PLAN AND ZONING COMMISSION MEETING

Case F21-07: Request of Palmer College Foundation for a Final Plat of a 3 lot subdivision on 5.56 acres located south of 12th Street, between Perry Street and Pershing Avenue. [Ward 3]

FINAL PLAT

FIRST ADDITION

FINAL PLAT

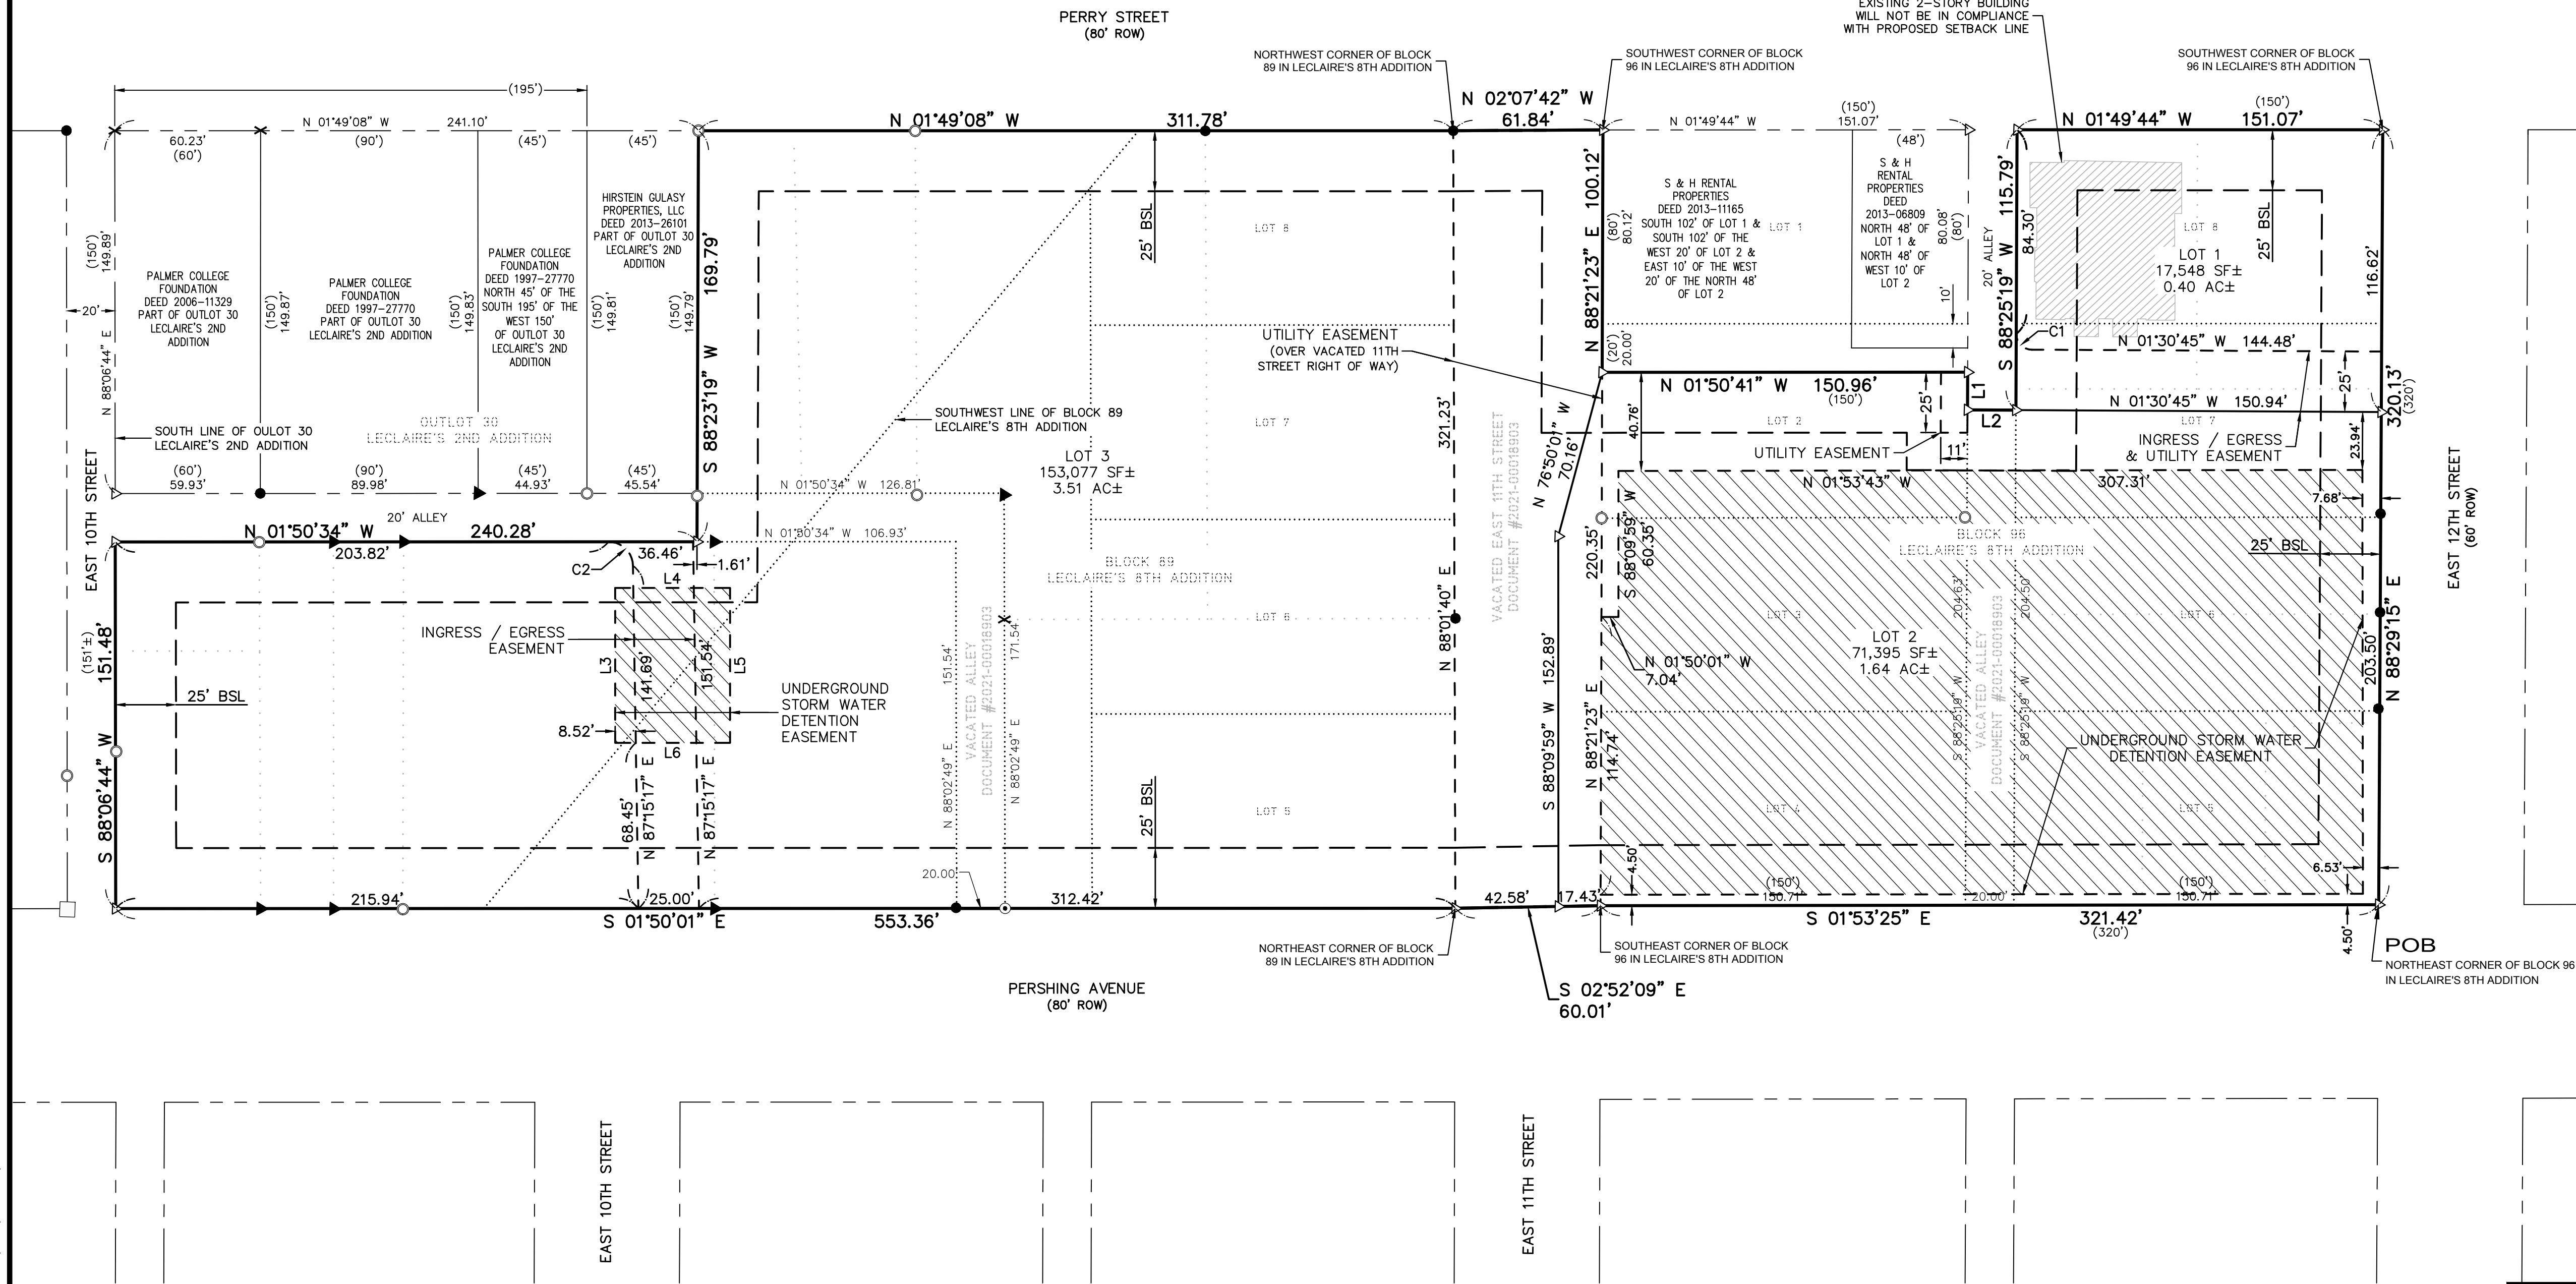
1. That the surveyor signs the plat.
2. That the utility providers sign the plat when their easement needs have been met.
3. Add 15' utility easements along all street frontages.

4. Provide a 15' utility easement along the former 11th Street right-of-way to accommodate a water main.
5. Include the curve central angles in the table.

6. Modify setback lines shown on the plat for conformance with the building footprints approved by City Council in Ordinance 2021-106.
7. Add a note stating, "Stormwater detention and water quality treatment are required with this subdivision and will be subject to the applicable ordinances in place at the time of development."

8. Revise the last Surveyor's Note to read, "Blanket access easements are granted to the City of Davenport for inspection of underground storm water detention easements."

9. Include a note stating, "The development associated with this plat is subject to the Palmer College of Chiropractic Campus Master Plan as amended in Ordinance 2021-106."

10. Add a note stating, "The vacated 11th Street right-of-way is subject to conditions in Ordinance 2018-107".

Add 15 foot utility easements along all city streets.

Remove the 'and maintenance' part of the blanket access easement for storm water sentence. AK

Please add a note stating that the development associated with this plat is subject to the Palmer College of Chiropractic Campus Master Plan as amended in Ordinance 2021-106.

Add a note stating that the vacated 11th Street ROW is subject to conditions in Ordinance 2018-107.
